Work Order ID 140738

Item ID: D350-588-041 Accept ***N900040100*** Setup Start ***NS1***
 Revision ID: Stop ***NS2***
 Item Name: Aft Door Assembly
 Start Date: 1/18/2016 Start Qty: 1.00 ***1*** Cust Item ID:
 Required Date: 1/18/2016 Req'd Qty: 1.00 ***1*** Customer:
 Reference:

DART SERVICE INSTRUCTION

TO AMEND INSTALLATION INSTRUCTIONS D350-588 REV. D AND
INSTRUCTIONS FOR CONTINUED AIRWORTHINESS ICA-D350-588 REV. 0
REF TCCA STC SH82-41
FAA STC SH1012NE

Figure 1 Striker Plate

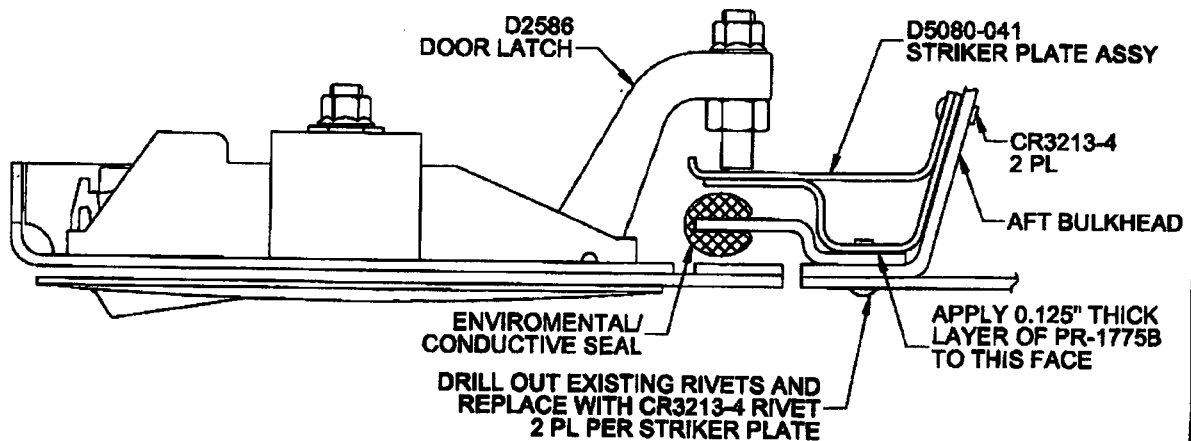
The purpose of this Dart Service Instruction is to provide customers with directions to install a modified striker plate that will provide more clearance around environmental/conductive seals that protrude inboard of the door frame structure on AS355 N/NP models.

- 5) Align D5080-041 striker plate assembly in the previously marked location and transfer drill the $\varnothing 0.1285"$ (#30) holes into the aft bulkhead.

- 8) Deburr holes and remove all sharp edges.
- 9) Touch up all holes in aluminum with chemical conversion coating in accordance with MIL-DTL-5541.
- 10) Apply 0.125" thick layer of PR-1775B ProSeal to the face of D5080-041 per Figure 1.

- 11) Install D5080-041 striker plate assemblies to the aft bulkhead using CR3213-4 rivets of a suitable length, and to the skin of the aircraft using PR-1775B coated CR3213-4 rivets of a suitable length.

588 -041	588 -011	PART NUMBER	DESCRIPTION
X		D350-588-041	AFT DOOR ASSEMBLY
	X	D350-588-011	AFT DOOR FWD HINGE MOD
2	2	D5080-041	STRIKER PLATE ASSY (AS355 N/NP MODELS ONLY)
2	2	D2237	STRIKER PLATE
